Sawtooth National Forest
Burley – Twin Falls Ranger
District

In August and September 2002, several surveys were conducted for the proposed expansion of your current operations at the Dove Creek Quarry in the Raft River Range. These surveys were done for the preparation of a Biological Evaluation of the possible impacts to threatened or endangered plant and animal species. Surveys were also conducted of spring and seep areas in the proximity of your proposed operations to determine possible impacts to water quality and riparian areas. We are also reviewing cultural report maps of the area to see if the areas of your proposed expansion are covered by existing cultural reports. These reports will need to be done before we can complete the environmental assessment of your proposed operations. We are in the process of sending out a scoping letter for your proposed operation to assist us in the environmental assessment process.

Enclosure: Proposed Expansion Map

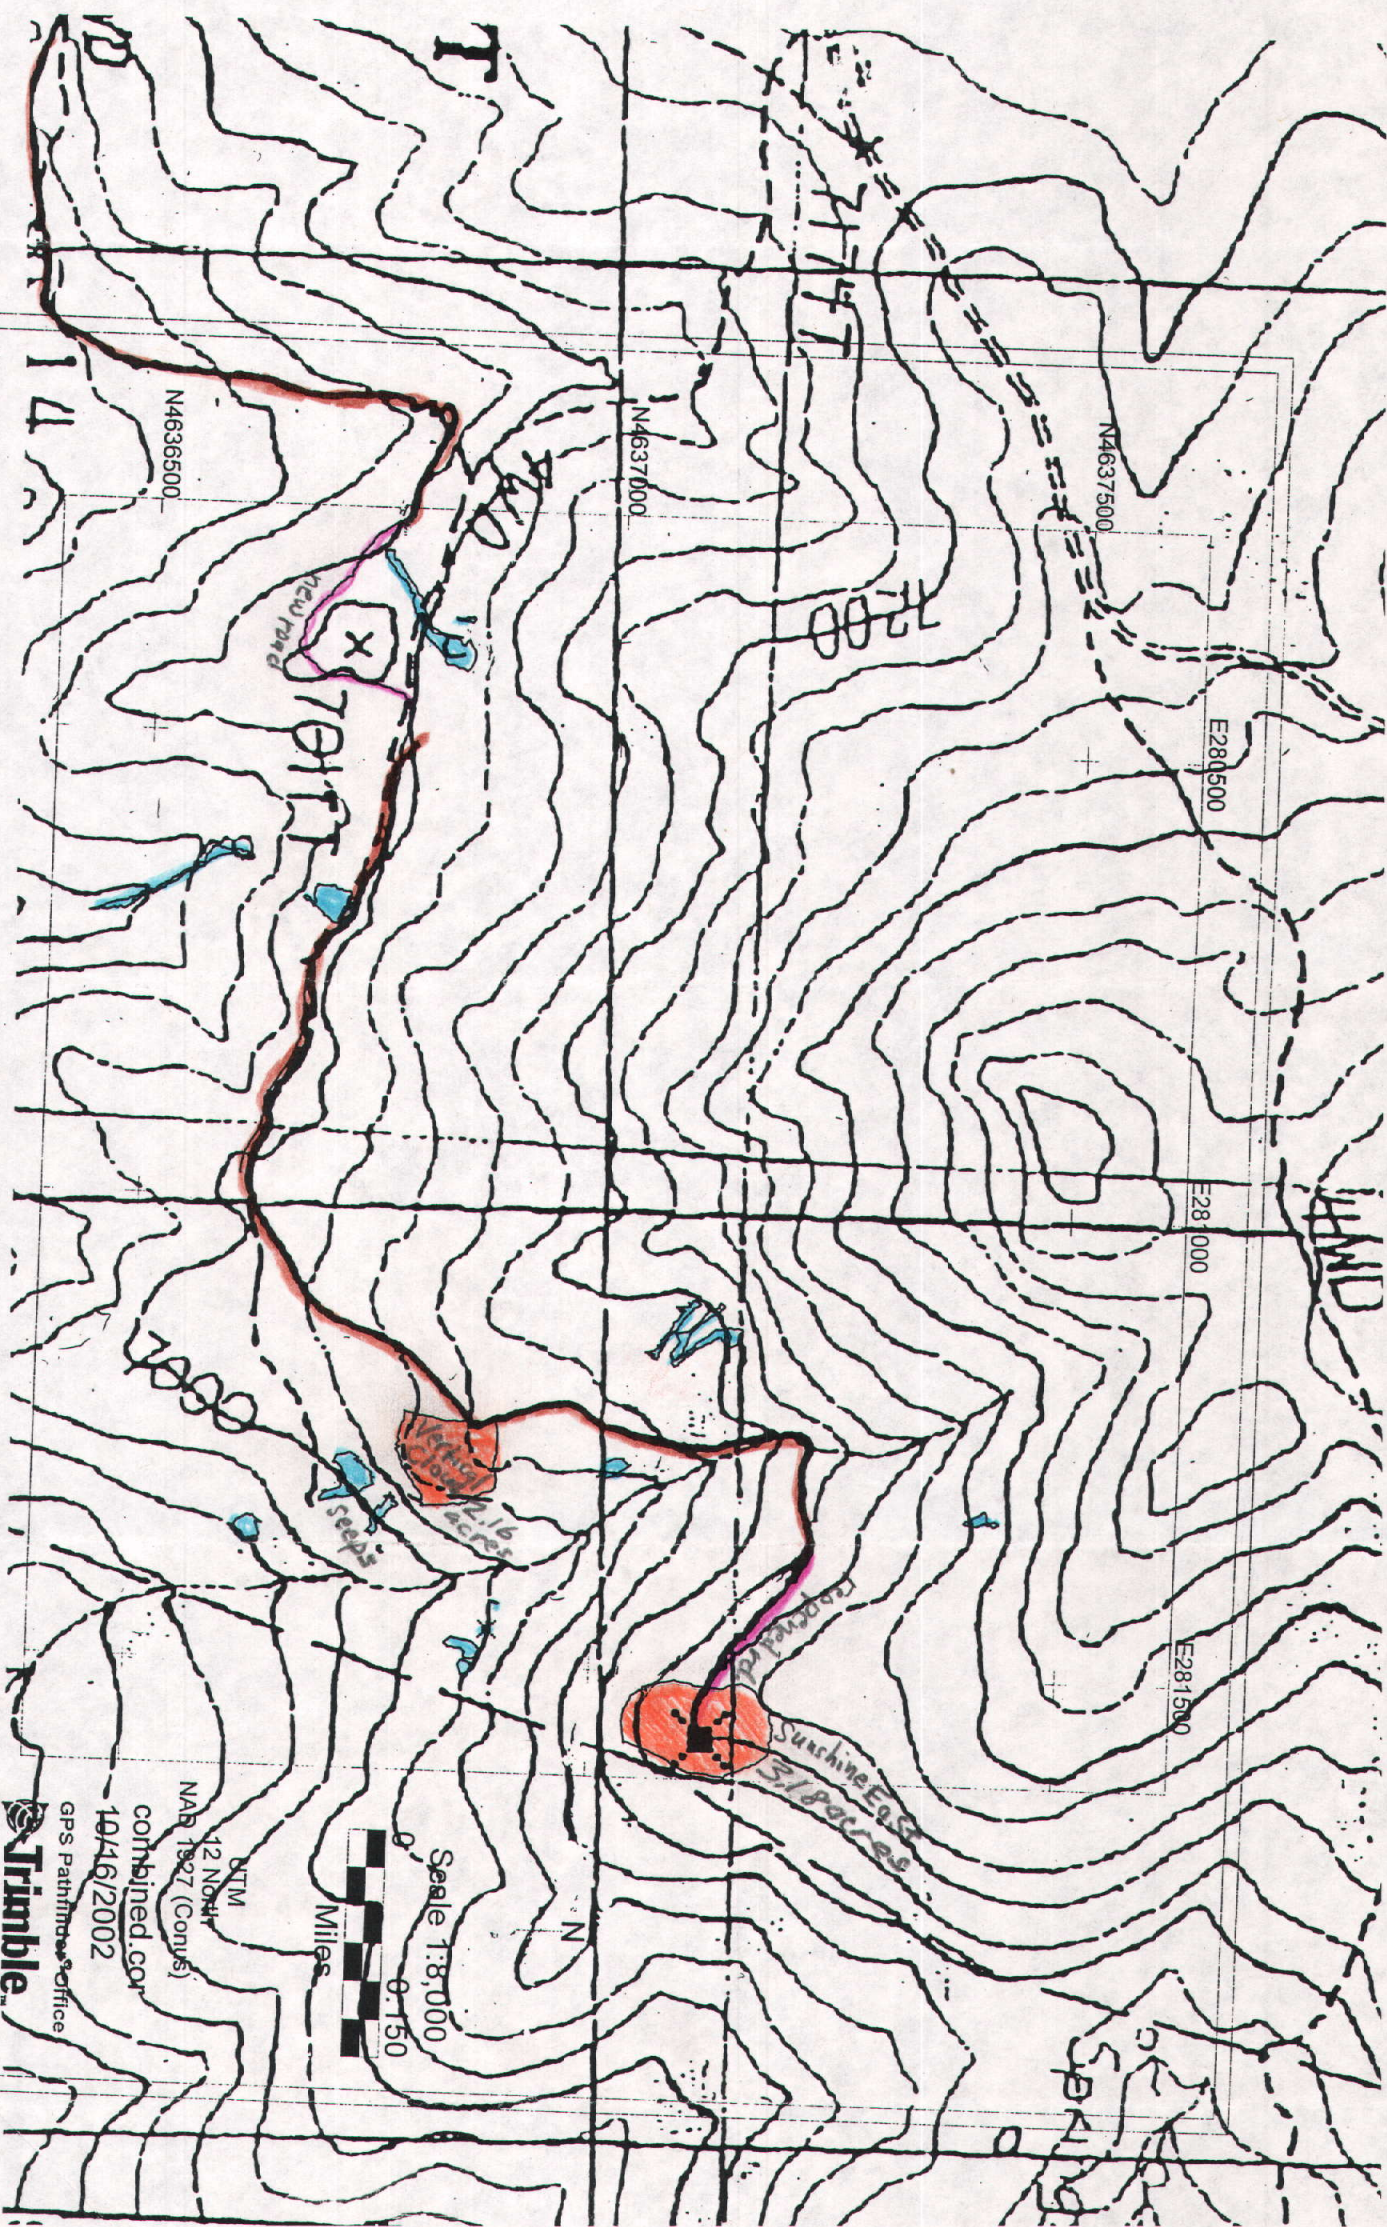
During the surveys, it was determined that of the two routes that you had flagged to avoid the damaged spring area, the northernmost route would involve the least amount of new ground disturbance and would have less impact on other seeps and springs in the area. If this route is used, then the section of the road where it crosses the dry stream channel should be graveled to avoid sedimentation during wet periods. Also, where this proposed road intersects the old two-track road there are several small meadow areas that could be avoided by tying directly into the Interstate Road and not using the two-track route.

We also found during the surveys a seep area directly below the proposed Vertical Cloud Quarry that appears saturated and unstable. During one of our visits, Preston indicated that waste rock could be placed in a way so as not to cover this seep area.

As we have discussed in the past, you will need to submit further information for your plan amendment that addresses the utilization and reclamation of the Interstate Road and the construction of the new section of road to avoid the damaged spring area. You will also need to address how you will conduct operations at the Vertical Cloud Quarry to avoid impacts to the seep area. We will also need to know if you plan to expand the existing quarries considerably and what your plans are for public access through the new quarry areas. Enclosed is a map showing seep and spring areas in the proximity of your proposed operations including the seep areas below the Vertical Cloud Quarry.
